I-405 David C. Walker and Elsa L. Morris

Comment Letter Responses

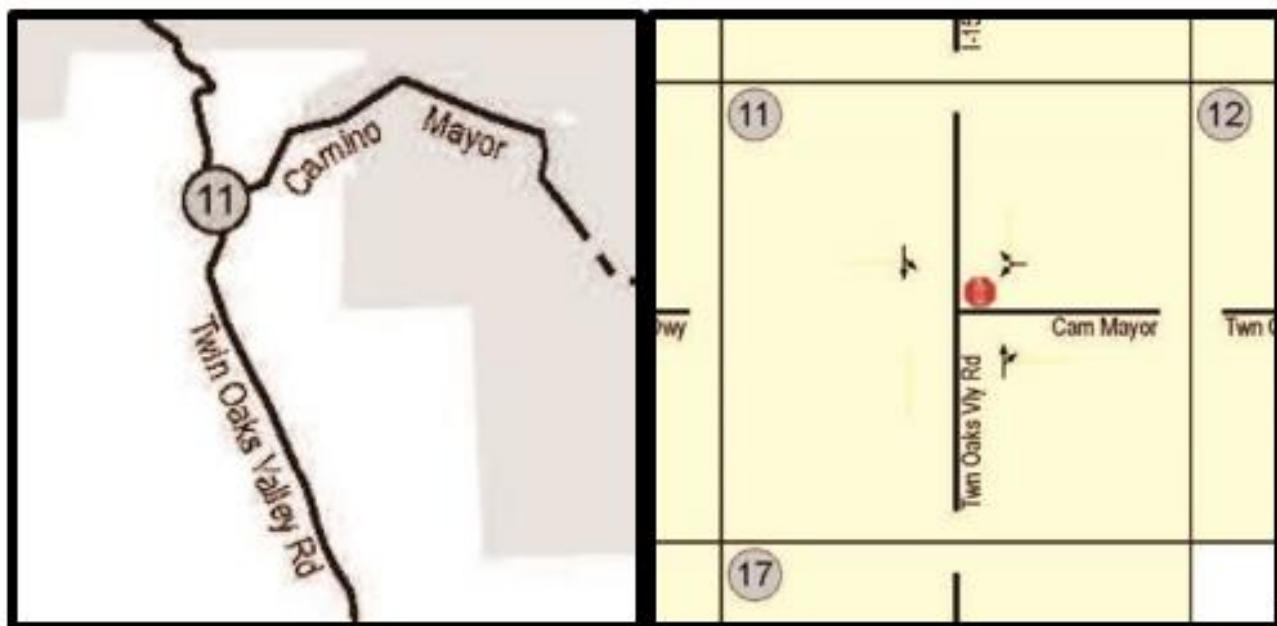
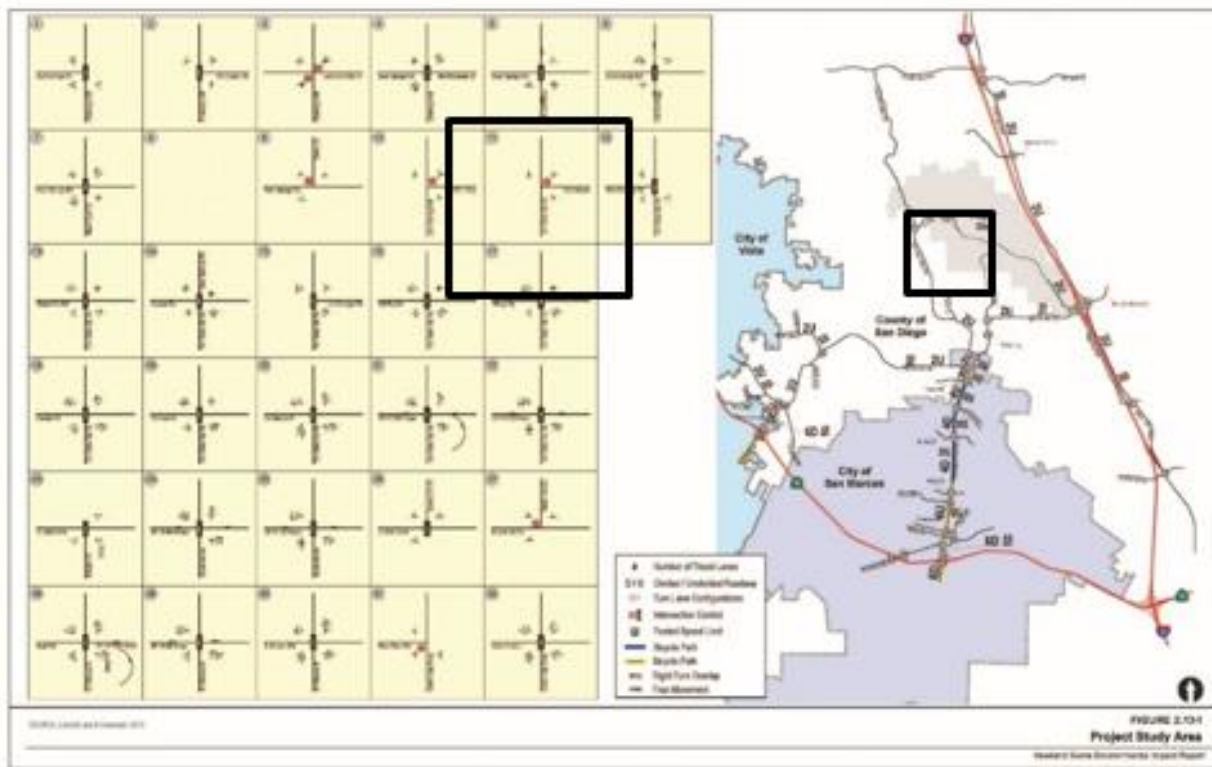
state that the maximum ADT for Camino Mayor is 320. The comment states that Figure 2.13-1 in Section 2.13 of the Draft EIR incorrectly shows Camino Mayor as signalized.

As to the ADT volume shown in the summary table of the Design Exception Requests, the estimate of 320 ADT pertains to the onsite portion of the road between the Summit neighborhood and Saddleback Park, and reflects the estimated internal project traffic between Saddleback Park and the project's other neighborhoods (e.g., Summit Neighborhood). As addressed in **Response to Comment I-405-16**, the offsite portion of Camino Mayor is forecasted to handle approximately 150 ADT from the project. For the purposes of evaluating the design exceptions, however, the higher volume of 320 ADT was used. Accordingly, the County does not agree that there are conflicting statements in the Draft EIR about the proposed use of Camino Mayor.

The County does not agree that Figure 2.13-1 shows Camino Mayor as signalized. The Figure shows the intersection of Camino Mayor and Twin Oaks Valley Road as intersection "11" and shows the intersection on the left side of the figure as a stop control for Camino Mayor, as follows (please note also the enlargement of these two areas in the figure located just below the top figure):
